# UNITED STATES PATENT AND TRADEMARK OFFICE

APPLICATION NO.	FILING DATE	FIRST NAMED INVENTOR	ATTORNEY DOCKET NO.	CONFIRMATION NO.
10/675,736	09/29/2003	Yong Shen	HSJ920030040US1	6375

**Office Action Summary**

FIG. 24A

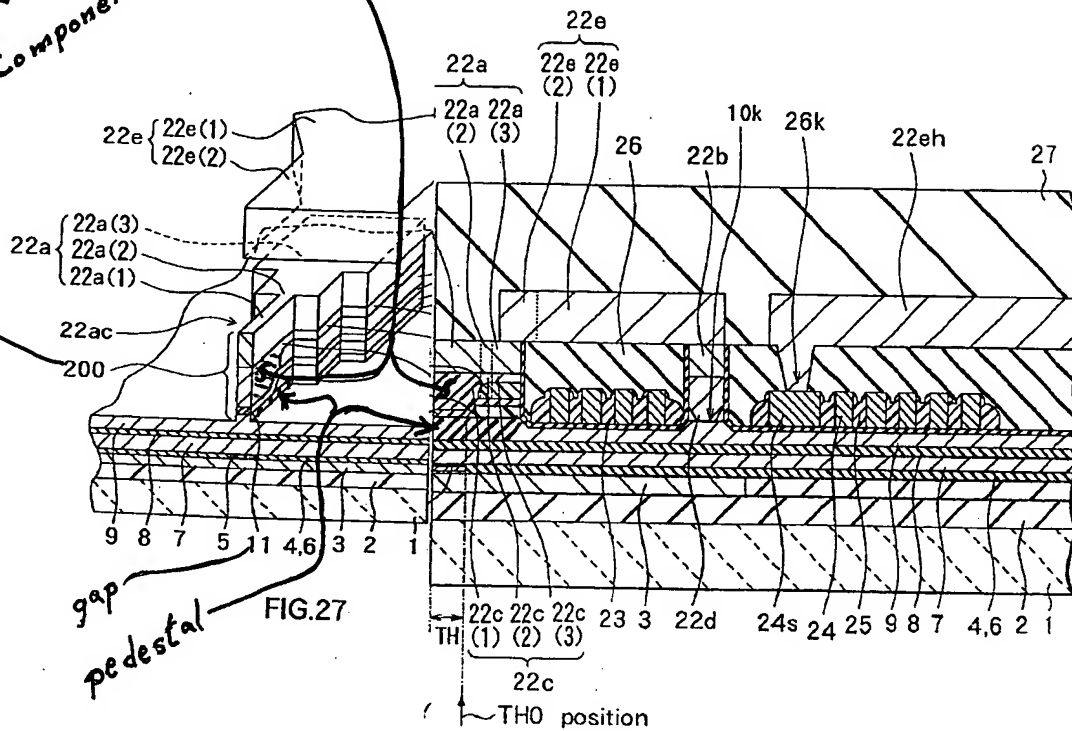
See Figs. 24A&B and 27. To the extent claimed and understood, the structure as shown in Addendum A reads on and performs to the same degree as claimed.

Note that the first component has a ZTH(noted in figure 24A and Addendum A as 'TH') which is less the height of the pedestal (blue section lines in Addendum A).

Second Pole Piece  
First Component
